SUBJECT: NORTH ANNA POWER STATION, UNIT NOS. 1 AND 2, ISSUANCE OF
AMENDMENTS TO CHANGE THE REACTOR COOLANT SYSTEM
PRESSURE AND TEMPERATURE LIMITS REGARDING VACUUM FILL
OPERATIONS (TAC NOS. MF4707 AND MF4708)

SAFETY EVALUATION BY THE OFFICE OF NUCLEAR REACTOR REGULATION

AMENDMENT NO. 275 TO RENEWED FACILITY OPERATING LICENSE NO. NPF-4

AMENDMENT NO. 257 TO RENEWED FACILITY OPERATING LICENSE NO. NPF-7

Figure 3.4.3-1 (page 1 of 1)
North Anna Units 1 and 2 Reactor Coolant System Heatup Limitations
(Heatup Rates up to 60°F/hr),
Applicable for the first 50.3 EFPY for Unit 1, and 52.3 EFPY for Unit 2
(Including Margins for Instrumentation Errors)

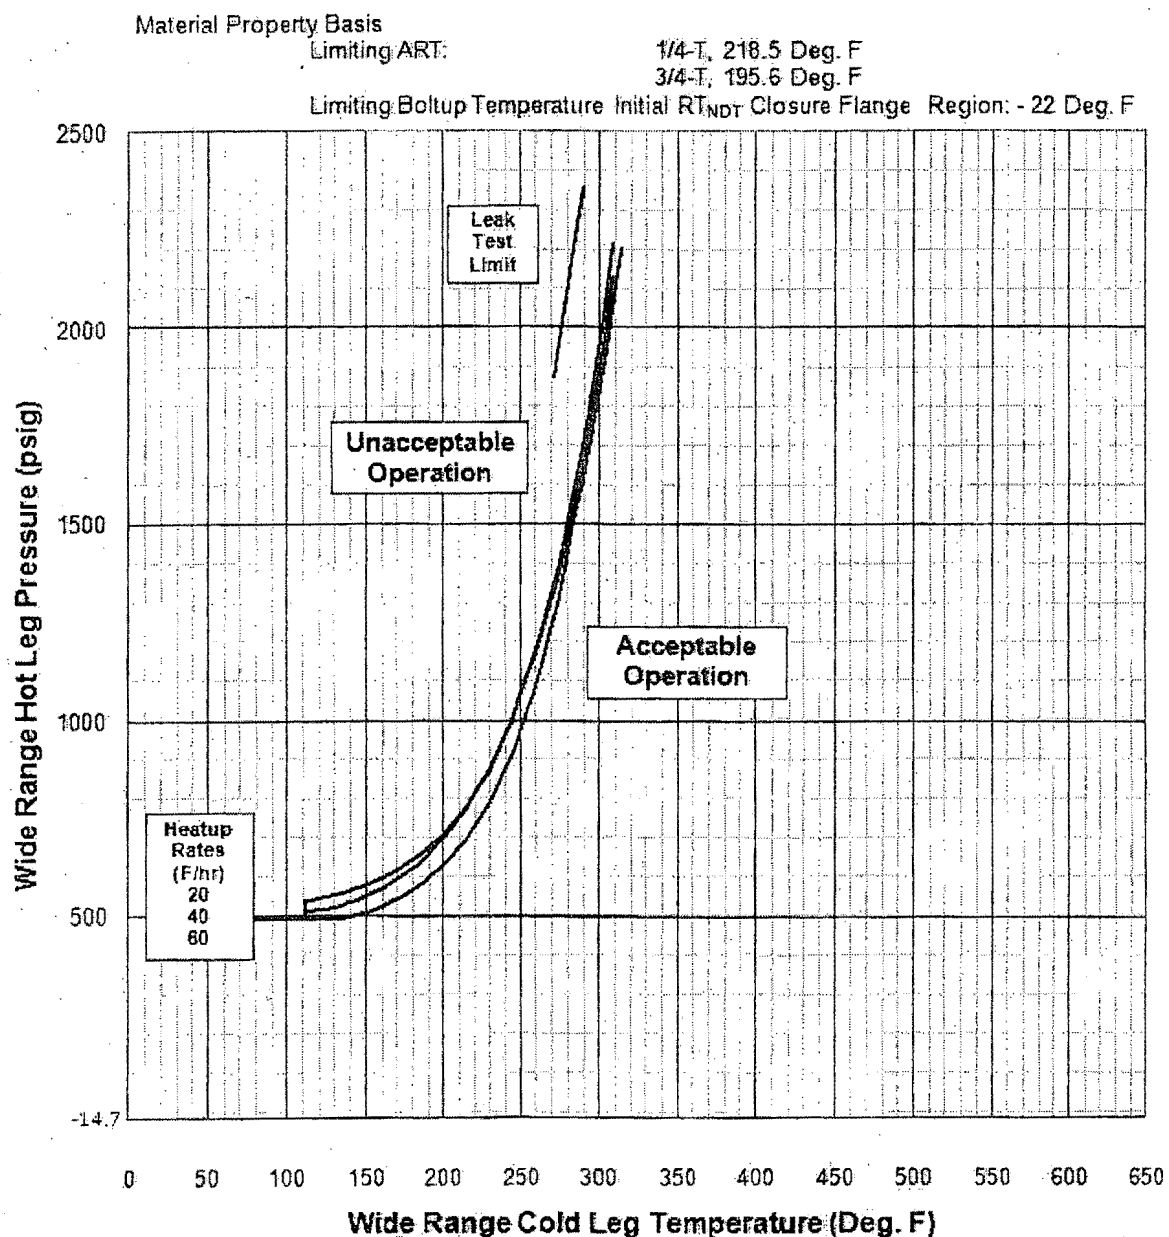
- The temperature axes are extended from 350 degrees Fahrenheit (°F) to 650°F, which bounds temperatures up to RCS full power operation.
- The pressure axes are extended from 0 psig to -14.7 psig to bound RCS conditions to support vacuum-assist fill of the RCS loops.
- The phrase, "Limiting Boltup Temperature North Anna Initial RT_{NDT} Closure Flange Region: -22°F," is added, since the current figures do not address boltup temperature.

As revised, Figures 3.4.3-1 and 3.4.3-2 would each contain an additional note stating, "Limiting Boltup Temperature North Anna Initial RT_{NDT} Closure Flange Region: -22°F." This note is a true statement and is consistent with existing requirements. Therefore, the staff finds the additional note acceptable.

The NRC staff concludes that the proposed changes to the NAPS 1 and 2, TS figures 3.4.3-1 and 3.4.3-2 meet the requirements of 10 CFR Part 50, Appendix G.
